# A FLECK PERFORMANCE BULLETIN

September 25, 1996

## No Hard Water By-Pass Pistons

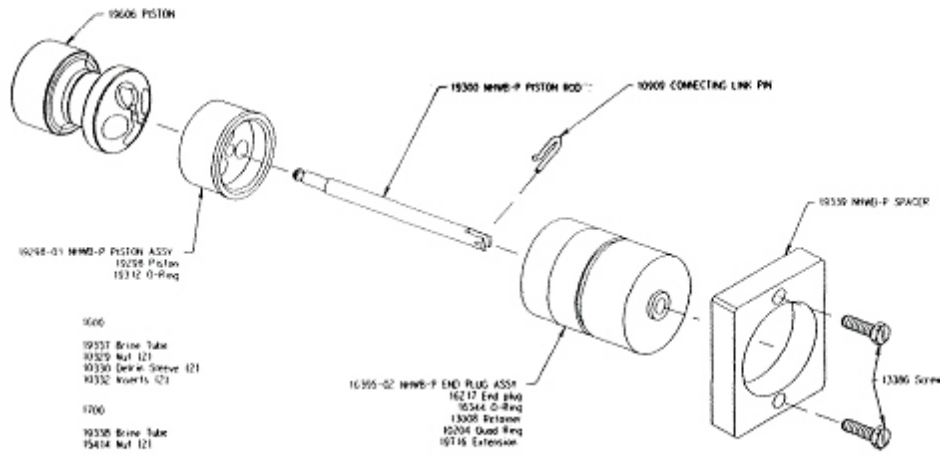
No hard water by-pass pistons are now available for the 2750, 2850 and 3150 controls. To modify a 2750 or 2850 control in the field, a conversion kit is needed. All conversion kits consist of a spacer (between the valve body and backplate) and longer screws. For 1600 and 1700 brine systems, longer brine tubes and the necessary hardware are included. For existing 3150 controls a piston assembly is all that is necessary. The diagrams illustrate the individual parts that make up these assemblies.

NOTE: The no hard water by-pass piston will NOT take the place of a 3 or 4 way solenoid with diaphragm valve to keep the control in stand-by for (Alternating) System 7.

The no hard water by-pass piston WILL take the place of an SVO with diaphragm valve for Systems 5 and 6.

The 2750 no hard water by-pass piston and conversion kits WILL also work in the 1500, 2500 and 2700 control valves.

# 2850

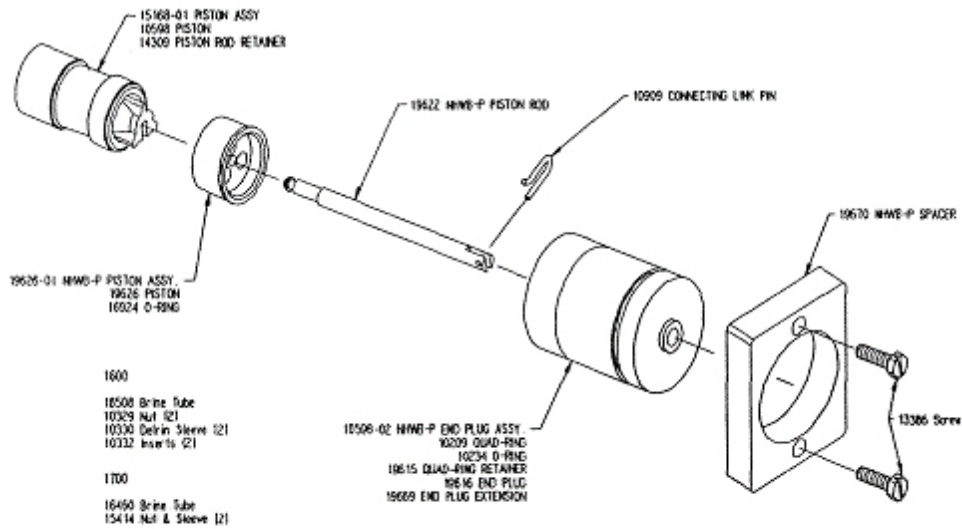
<u>VALVE</u>	<u>PART#</u>	<u>DASH # AND DESCRIPTION</u>
2750	60101	-00 Filter Conversion Kit -01 Piston Assembly Only -02 1600 Conversion Kit -03 1700 Conversion Kit
2850	60114	-00 Filter Conversion Kit -01 Piston Assembly Only -02 1600 Conversion Kit -03 1700 Conversion Kit
3150	60113-01	NO CONVERSION KITS NEEDED
